CERTIFICATE OF APPROPRIATENESS

Property: 1215 Rutland Street, lot 14, block 183, Houston Heights Subdivision. The property consists of a vacant 4,356 square foot (33' x 133') interior lot.

Proposal: New Construction – Residence *REVISION*

EAST ELEVATION – FRONT FACING RUTLAND

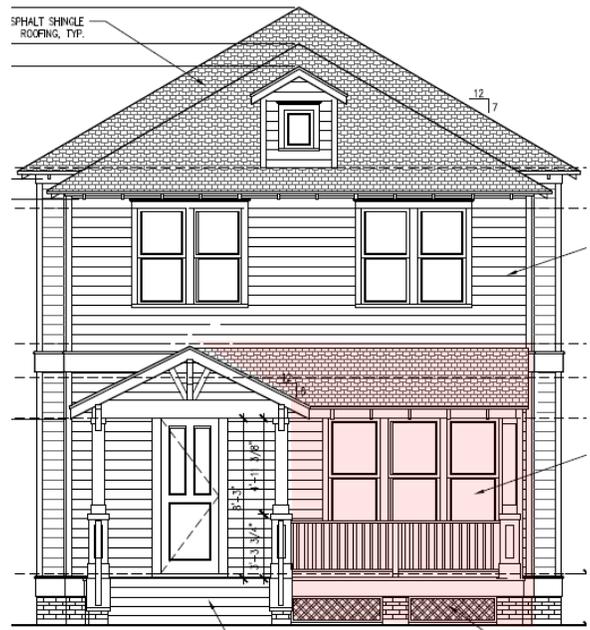
Proposed Revision: The half width front porch will be replace with one that will now span the full width of the front wall. The revised porch will measure 22' 6" wide by 6' 6" deep.

NORTH SIDE ELEVATION

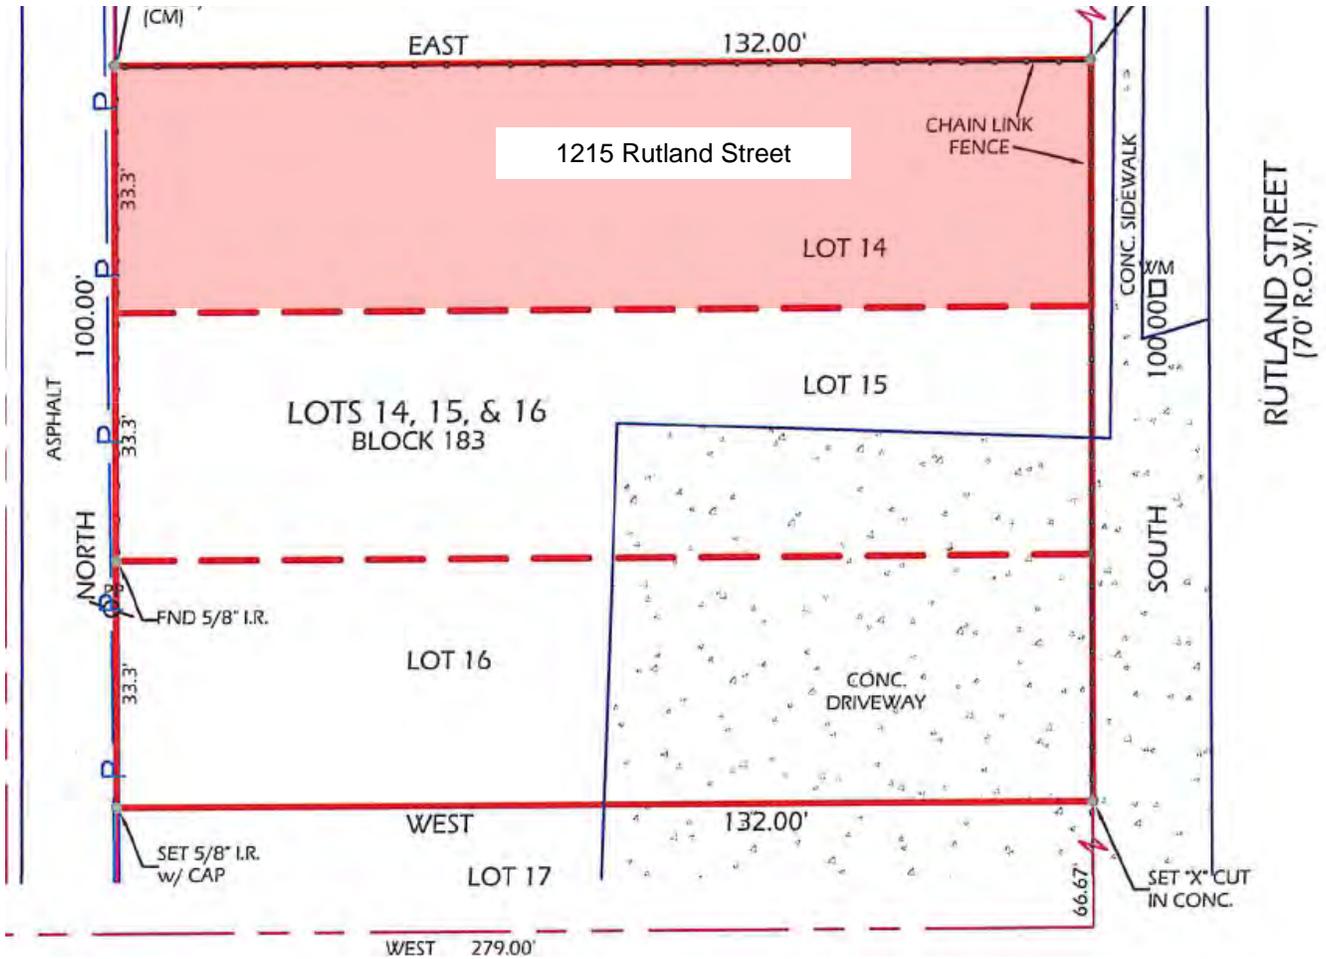
Proposed Revisions: Reduce the depth of the residence and attached garage by 5'. The eave height of the approved attached rear garage will be reduced from 19' 6" to 18' 6". The ridge height of the garage has been reduced from 27' to 25' 10".

SITE PLAN

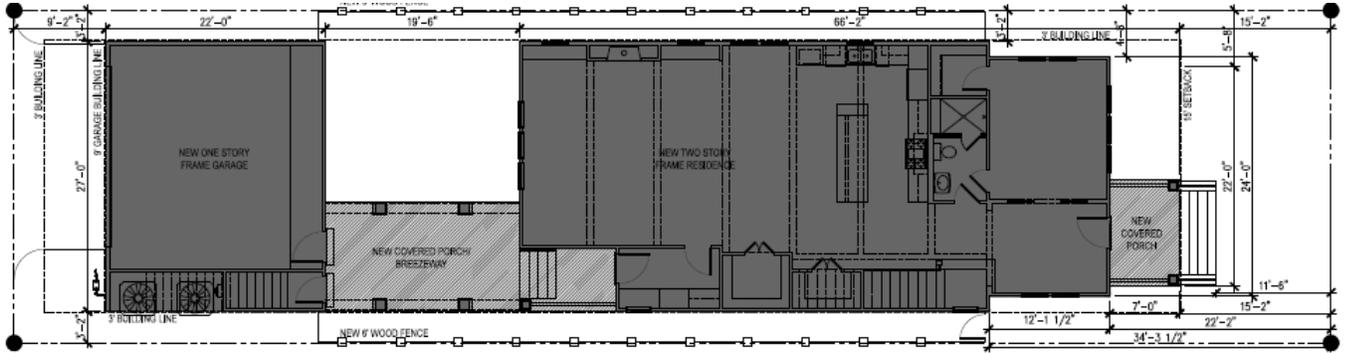
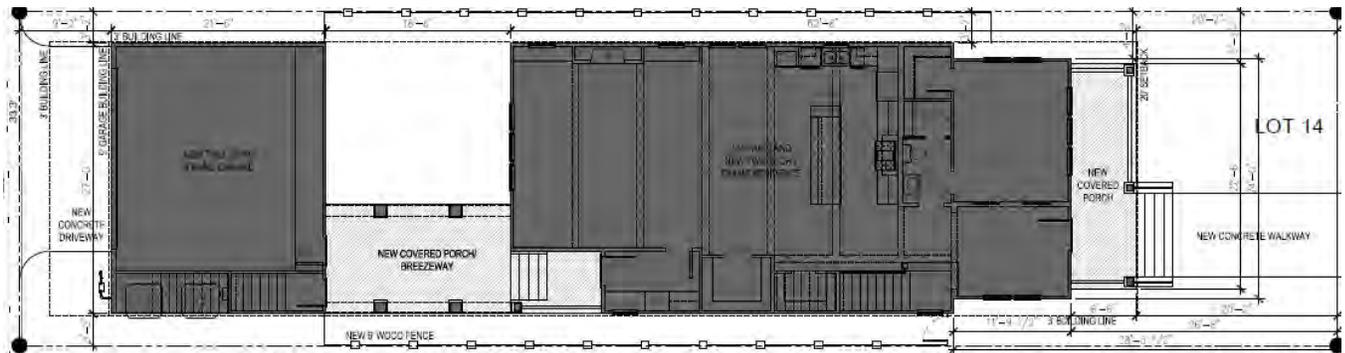
- Applicant granted was granted a conditional COA on February 26, 2015, on the condition that the residence be set back 20' from the front property line instead of the proposed 15'. The applicant now proposes to reduce the depth of the proposed residence by 5' in order to comply with the previous COA's conditions.
- Applicant also proposes to change their approved covered front stoop to a full width front porch
- The eave and ridge heights of the approved attached rear garage will be reduced by 1' and 1' 2" respectively.

Proposed Revision: Setback has been increased to 20' from the front property line.
